Comments of Lisa Ledwidge, Institute for Energy and Environmental Research, at the U.S. Department of Energy public hearing on the supplement to the Surplus Plutonium Disposition Environmental Impact Statement, June 15, 1999

Comments of the Institute for Energy and Environmental Research (IEER) on the on
Supplement to the Surplus Plutonium Disposition Draft Environmental Impact Statement
(DOE/EIS-0283-DS, April 1999)

**Comment on Supplement to the Surplus Plutonium Disposition
 Draft Environmental Impact Statement (DOE/EIS-0283-DS)**

Fig. 5-2 Heat Generation of Spent UO_2 and MOX Fuel

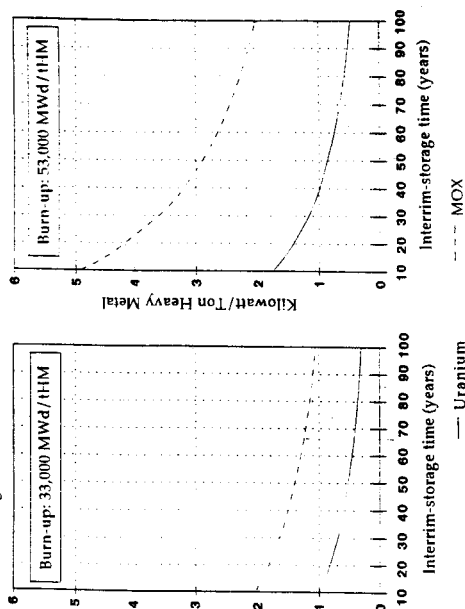
I reference the International MOX Assessment report entitled the Comprehensive Social Impact Assessment of MOX Use In Light Water Reactors by J. Takagi et.al., 1997 by Pub. Citizens Nuclear Information Center, Tokyo, Japan, page 190 shows the following table for decay heat generation is presented:

Higher heat generation means MOX fuel must be stored in the cooling ponds longer and will generate more heat in a repository. I add that higher fissile material concentrations in spent MOX fuel will also be higher creating a greater criticality danger.
